P&Z CASE # SP2020-025 P&Z DATE 10/13/20 CC DATE 10/19/20 APPROVED/DENIED \_\_\_\_\_  
ARCHITECTURAL REVIEW BOARD DATE \_\_\_\_\_ HPAB DATE \_\_\_\_\_ PARK BOARD DATE \_\_\_\_\_

PROJECT NUMBER: SP2020-025  
PROJECT NAME: Site Plan for Ellis Center, Phase 2  
SITE ADDRESS/LOCATIONS: 1203 SIGMA CT, ROCKWALL, 75087

CASE CAPTION: Discuss and consider a request Harper J. Kuper of SVEA Industrial II, LLC for the approval of a Site Plan for the expansion of an existing industrial facility on a 1.915-acre tract of land being identified as a portion of Lot 3 and all of Lot 3A-R, Block C, Ellis Centre #2 Addition, City of Rockwall, Rockwall County, Texas, zoned Light Industrial (LI) District, addressed as 1203 Sigma Court, and take any action necessary.

09/24/2020: SP2020-025; Site Plan for Ellis Center Phase Two

**SITE PLAN | 1**  
 SCALE: 3/64" = 1'-0" A1.00

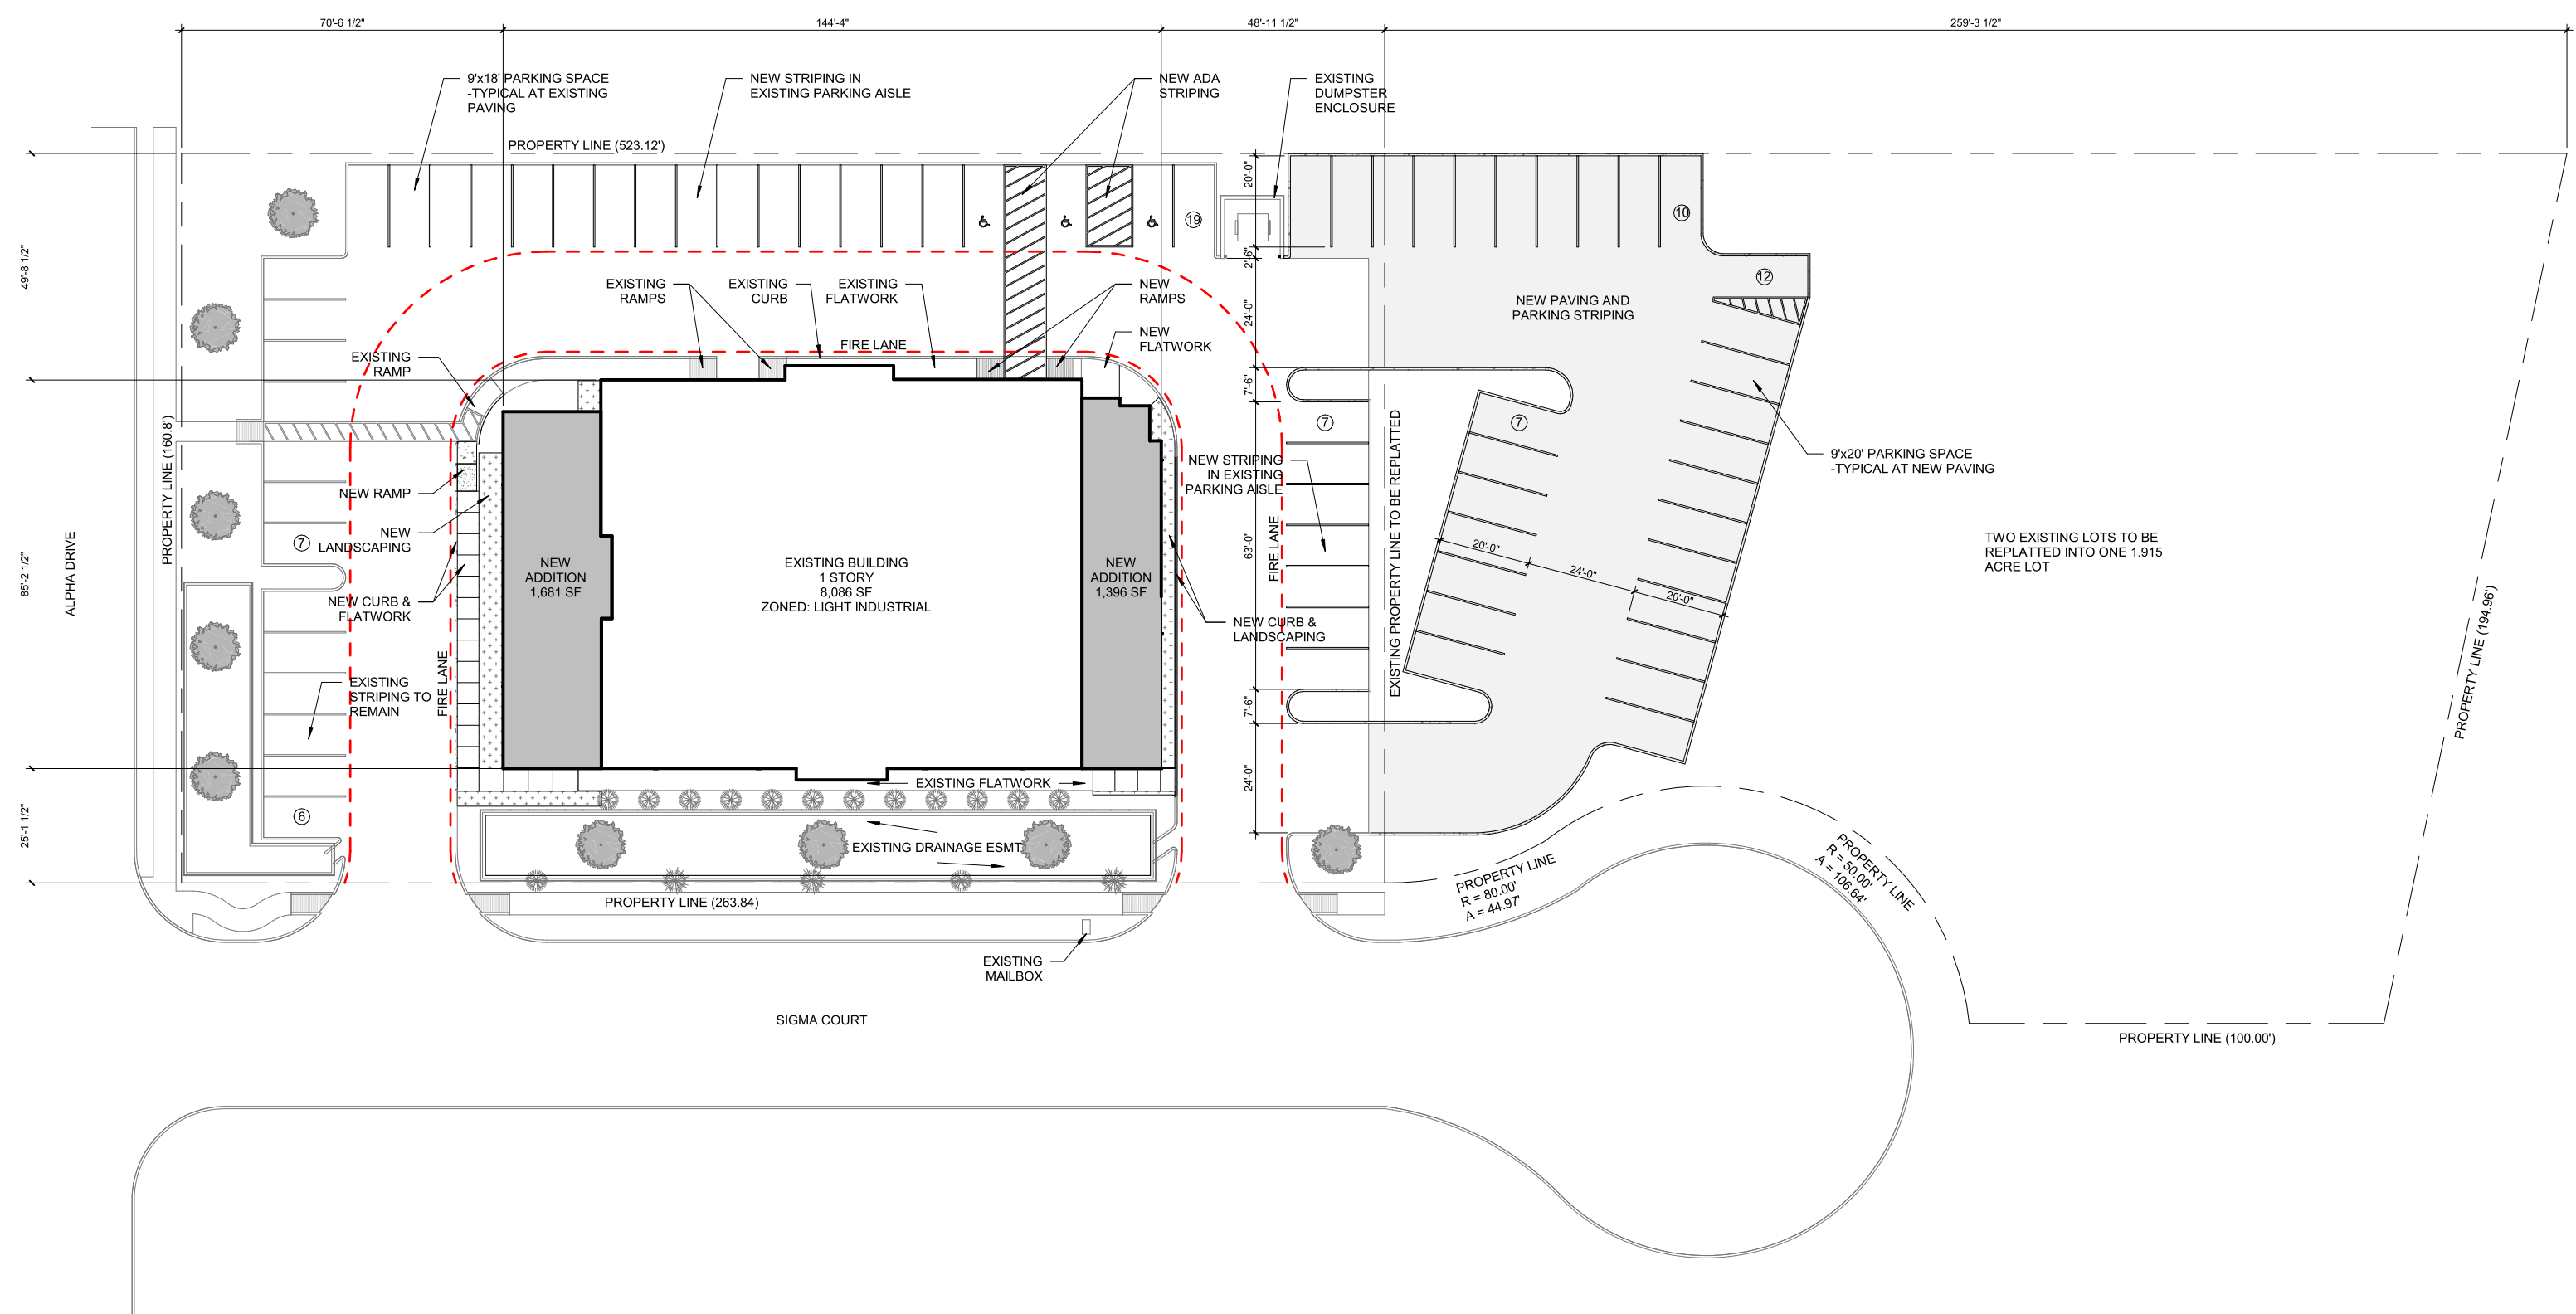
M.5 Site Plan:

1. Verify the total lot acreage. (Subsection 03.04.B, of Article 11)
2. Indicate the wall lengths of all buildings on the site. (Subsection 03.04. B, of Article 11)
3. Indicate all existing property lines. If the site plan requires a platting case that will alter the property lines show the proposed changes in a different line weight. (Subsection 0304. B, of Article 11)
4. Label the fire lane easements as Fire Lane, Public Access, & Utility Easement. (Subsection 03.04. B, of Article 11)
5. Parking is 1/300 not 3/1000. Make the correction on the parking table. (Table 5, of Article 6)
6. Show all proposed and existing utility equipment (pad/ground and roof mounted) and their subsequent screening. Roof mounted must not be visible from the street or adjacent properties. Utilize a taller parapet for screening. (Subsection 01.05. C, of Article 05)

LANDSCAPE PLAN | 1  
SCALE: 1/16" = 1'-0" | L1.00

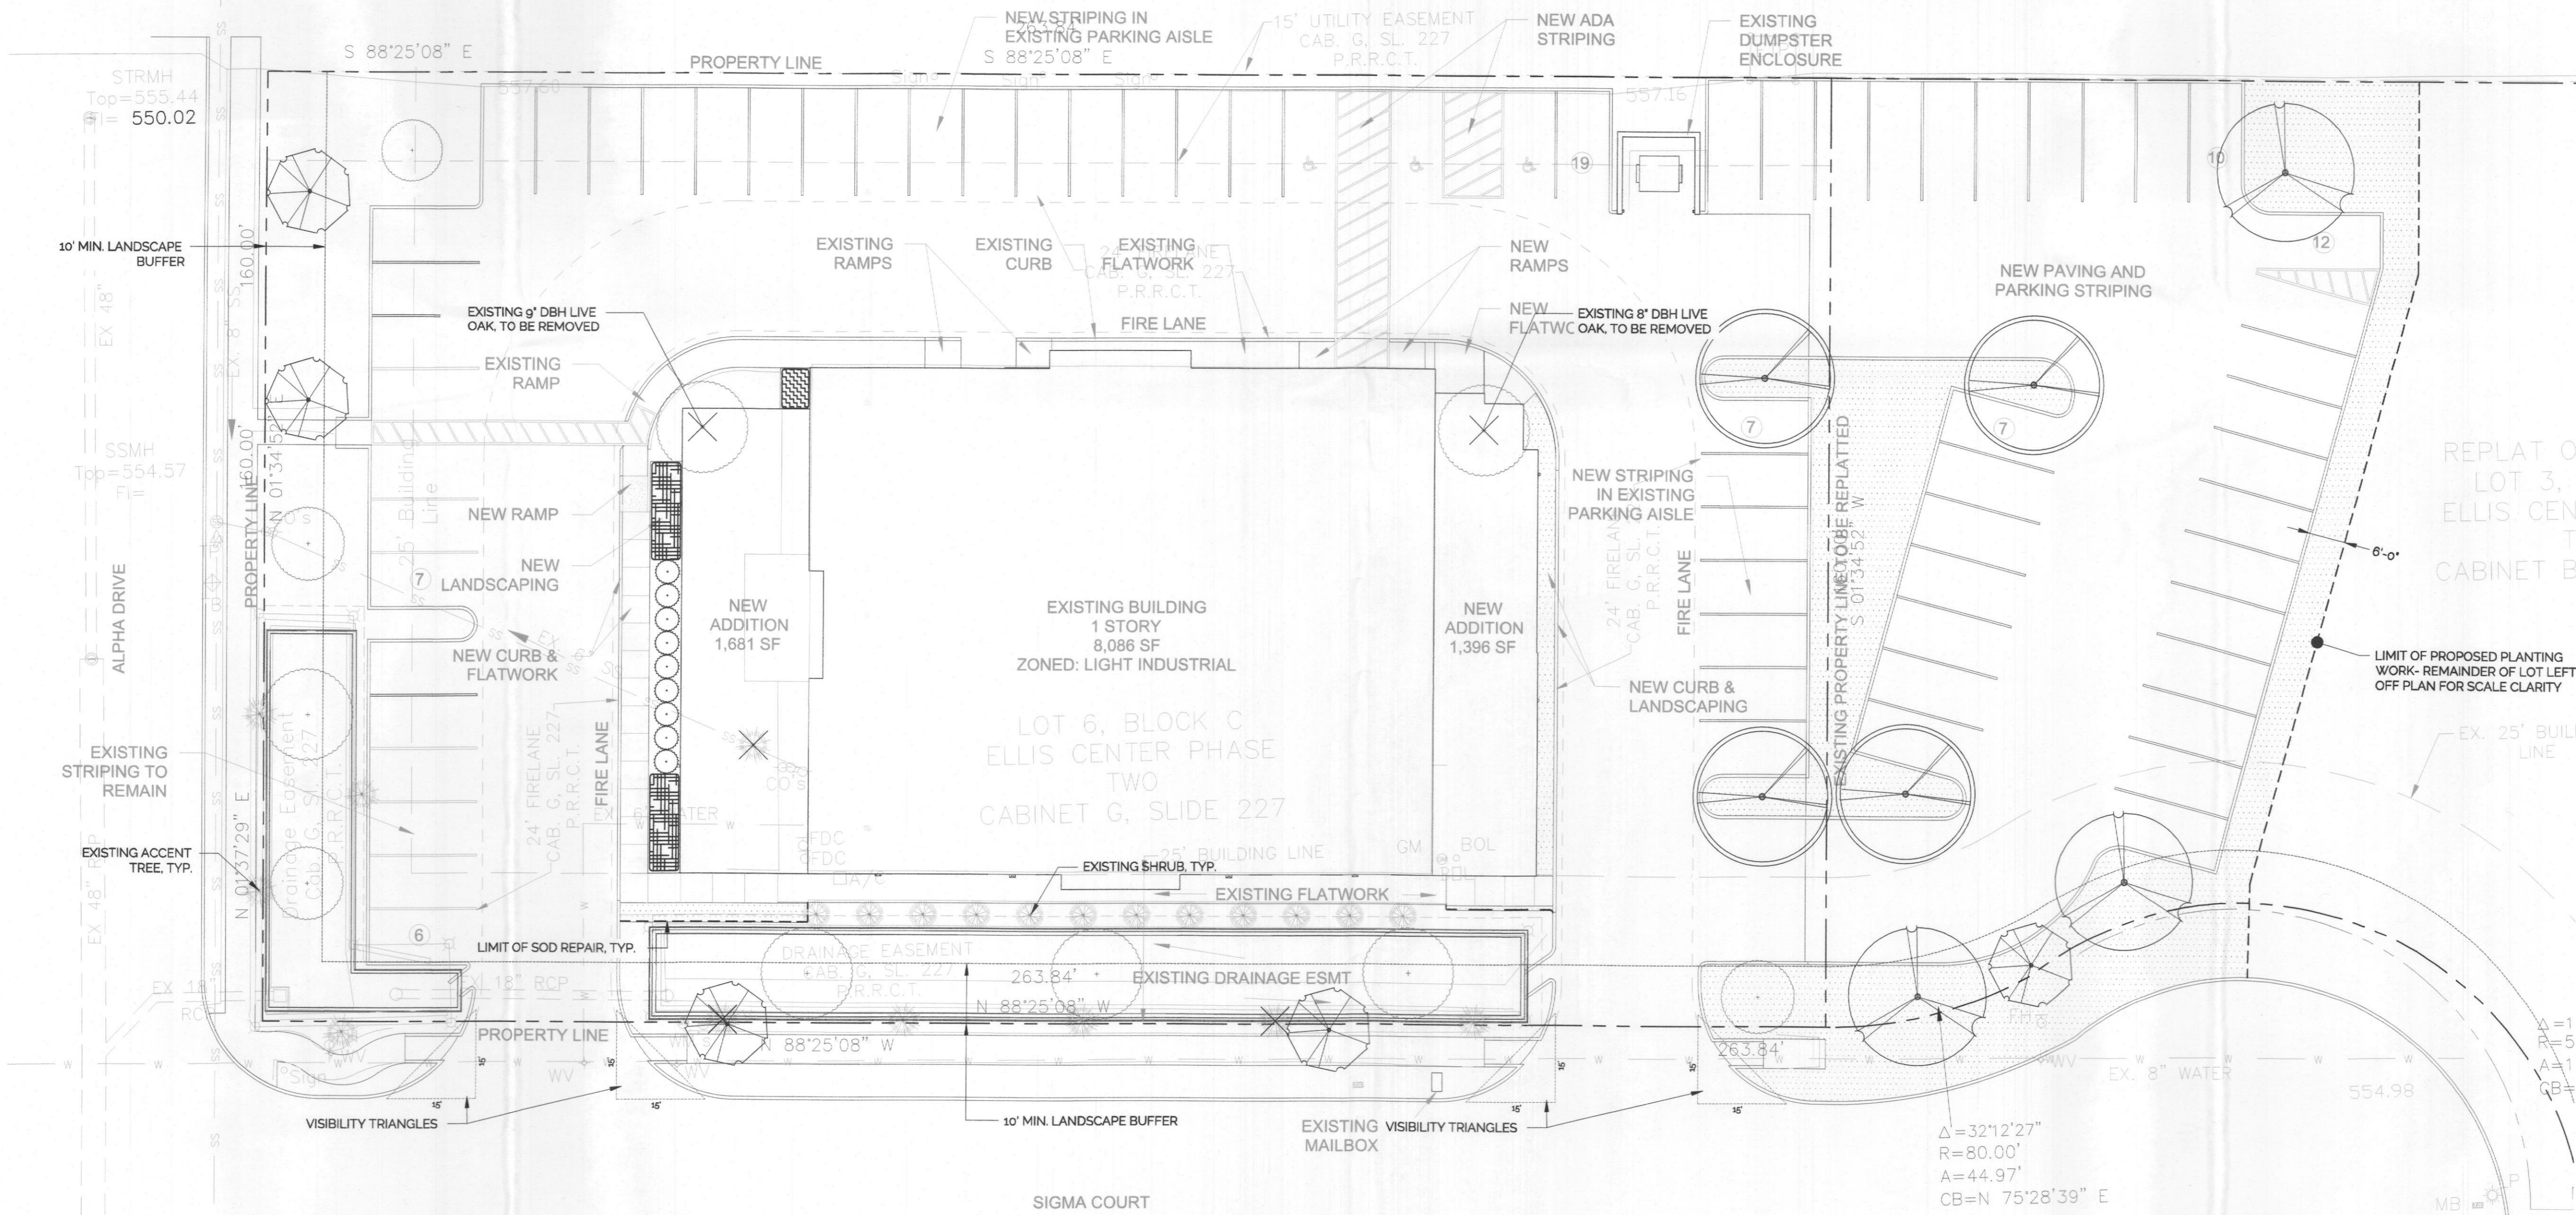
M.6 Landscape Plan:

1. Provide a landscape table showing plant materials, quantities, size and spacing for existing and proposed landscaping. Complete description of plant materials shown on the plan, including names, locations, qualities, container or caliper sizes at installation, heights, spread, and spacing requirements should also be listed on the plan. (Subsection

5. Indicate the location and provide a description by type and size of all existing protected trees (4" or larger) proposed to be retained. Such trees shall be marked and a drip line of said trees shall be protected prior to and during all construction, including dirt work. (Subsection 03.01. E, of Article 09)

7. Provide a table showing the total inches of trees to be removed and the total inches of trees to be replaced. (Subsection 03.01. G, of Article 09)
